Kentuckians for the Commonwealth

October 2022 (Revised October 28, 2022)

Kentuckians for the Commonwealth, Kentucky Solar Energy Society, and the Mountain Association engaged Energy Futures Group ("EFG") to review the East Kentucky Power Cooperative's ("EKPC" or "Cooperative") 2022 Integrated Resource Plan ("IRP"). EFG is a clean energy consulting company that performs IRP modeling and critically reviews IRPs in over a dozen states, provinces, and territories. We've reviewed over 100 integrated resource plans and similar exercises in our over 35 years of combined experience. Our work in these jurisdictions involves either conducting our own simulations and/or reviewing modeling conducted using a wide variety of electric system modeling platforms.

Figure 4. PJM Forecast of EKPC Zone Summer Coincident Peak and Winter Peak¹⁰

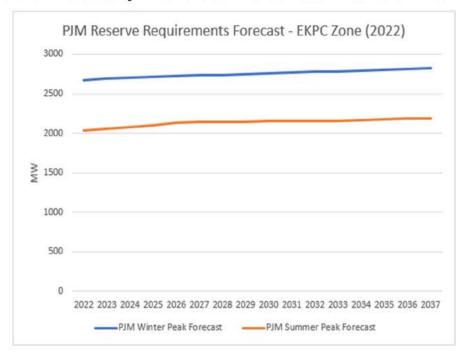
We further note that EKPC's next IRP would benefit from more forthright explanation of how their forecasting method necessarily differs from that of PJM, and to what effect. PJM's forecast in the EKPC zone and EKPC's own forecast do differ, and EKPC did analyze that difference. According to EKPC, there are several reasons why the PJM load forecast and its internal load forecast are not directly comparable to each other. But those differences and EKPC's analysis are not clear on the face of the IRP and needed to be drawn out through independent investigation and information requests. EKPC provided an explanation of the difference between its forecast and PJM's. However, this is a missed opportunity for

transparency and engagement in the process. Additionally, the PJM forecast would provide regulators and stakeholders an independent and public resource against which to compare EKPC's projections. Last, as a member of PJM, a discrepancy between the grid operator and utility in expected load growth should be resolved.

Figure 7. EKPC Natural Gas Forecast vs Current NYMEX Curve

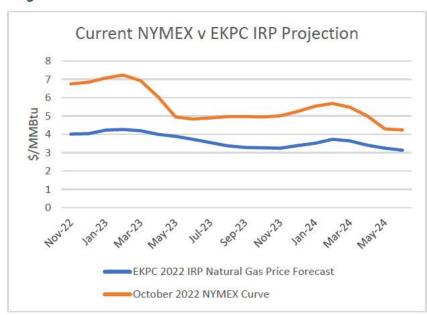
Natural gas prices forecast in EKPC's IRP, and reproduced below from December 2022 through June 2024 with the most recent NYMEX futures curve, as Figure 7, are also concerning. Likely due to the vintage of the forecast, EKPC is projecting the NYMEX Henry Hub price to drop dramatically below current market levels and forward projections. September December 2022 is in the forecast period for the natural gas price assumptions in 2022 IRP. EKPC projected natural gas prices to be approximately \$4/MMBtu at this time. Henry Hub is-futures are currently trading at nearly \$7/MMBtu, an increase of 75% over the Cooperative's modeled assumption. Although trading is thin, the NYMEX forward curve is consistently above \$4/MMBtu and near \$5/MMBtu through 2024.²² The NYMEX forward curve is readily available, and in future IRPs, we recommend that EKPC use the most recently available NYMEX curve or an approach that blends the near-term NYMEX trend with long-term fundamentals forecast.

Figure 8. EKPC Forecast of Energy Market Prices

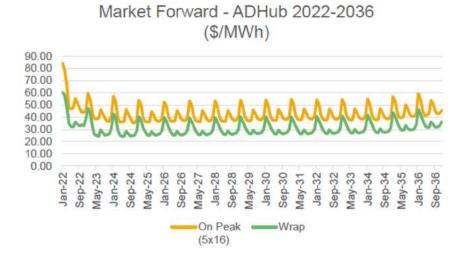
EKPC's energy market price forecast, reproduced above as Figure 8, is also low as compared to observed market prices. For example, the year-over-year average PJM AEP-Dayton Hub Locational Marginal Price (LMP) was \$63.37/MWh from September 1, 2021, to September 1, 2022. Thus far for 2022, the year-to-date average PJM AEP-Dayton Hub LMP has been \$71.24/MWh. The current average of PJM AEP Dayton Hub LMPs for September 2022 is \$82.28/MWh.²³ This is far above the forecasted energy market prices for both the forecasted contract prices.

Figure 13. EKPC Modeled Net Purchases (MWh)

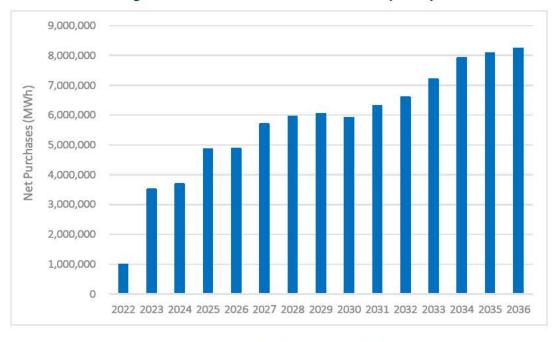
In combination with the operations of the Cooper units, EKPC is forecasting higher energy requirements, which means that EKPC expects that a decreasing proportion of its needs will be met by its own generation. In order for the model to meet the energy requirements and not have any shortfall periods, the model purchases more energy from the market. Figure 13 shows the modeled net purchases for EKPC over the planning period, which indicates an increasing level of market purchases.

Figure 18. Participation by Program

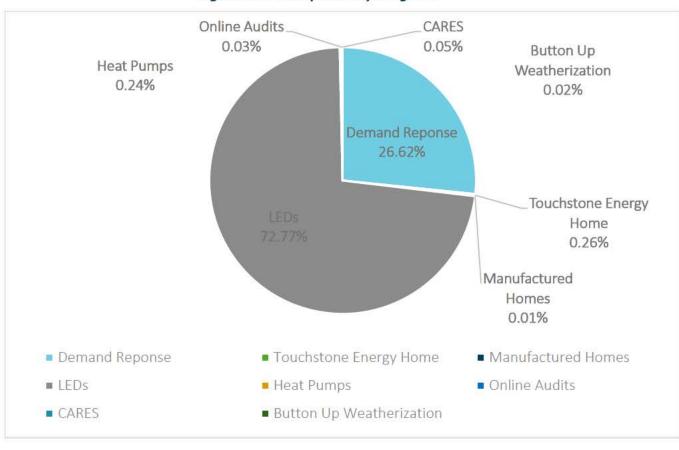
EKPC's residential DSM programs have minimal participation per year when compared to the total number of customers. Figure 18 below shows the level of participation by program. LEDs and demand response contribute almost all of the 2021 participation, with all other programs accounting for 0.61% of participation.

Figure 19. Participation Excluding LEDs and Demand Response

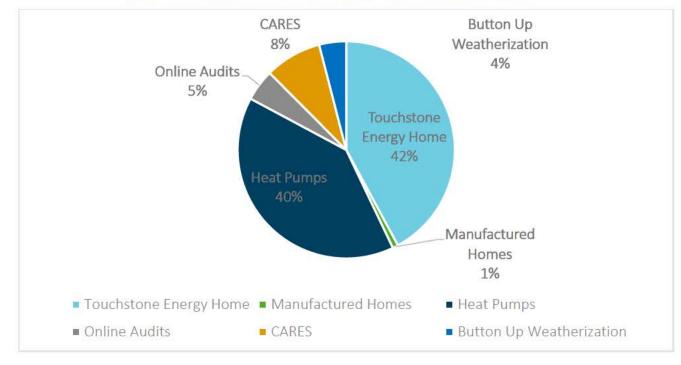
Outside of the LED and the demand response effort, the Heat Pump Retrofit Program and Button-Up Weatherization programs are the only programs that implement energy efficiency in existing homes. The CARES, Touchstone Energy Home, and Manufactured Homes programs rely on the cooperatives working with CAAs and manufacturers/builders, respectively. Based upon the breakdown in Figure 19, this means that only 44% of the 0.61% of the participation identified in Figure 18 is with owner-members. The reason for the lack of participation in the energy efficiency programs is likely two-fold. First, as identified above, the rebates are for minimum efficiency standards and therefore do not support the adoption of more efficient technology. There is no incentive for customers to choose higher efficiency options and the

rebate levels are not offsetting the cost of the higher efficient technology. Second, there is a lack of marketing of the energy efficiency and demand response programs.

One recommendation is to increase the content on EKPC's energy efficiency webpage. This page includes a list of the programs with a one-sentence description. However, it lacks information on how to participate in the programs, rebate levels, eligible contractors and measures, and the benefits of energy efficiency. At a minimum, EKPC should revise its website, referenced in Figure 20, to include the information identified above and provide links to its member cooperatives to allow for members to find out how to participate.
